Product information - Brake pads | HELLA

Brake pads

8DB 355 011-401 / 8DB 355 015-961

Changed brake pads

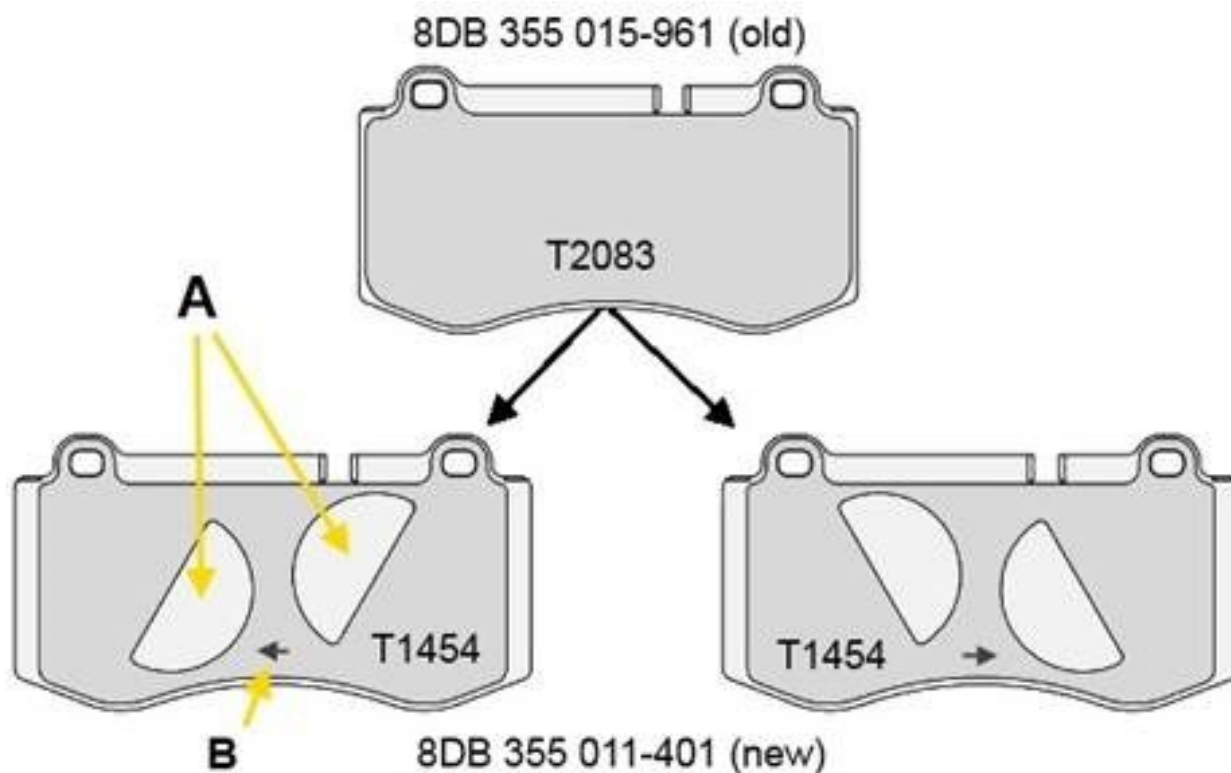
Brake pad 8DB 355 015-961 / T2083 will be replaced by brake pad 8DB 355 011-401 / T1454.

The difference between both brake pads is a change to the damping plate on the back plate of the brake pad. This change improves the noise sensitivity and thus, the comfort properties of the brake pads.

A new driving direction-related installation is necessary for the new damping plate with recess (A). The installation direction is indicated by an arrow (B).

A special assembly instruction is enclosed in every box.
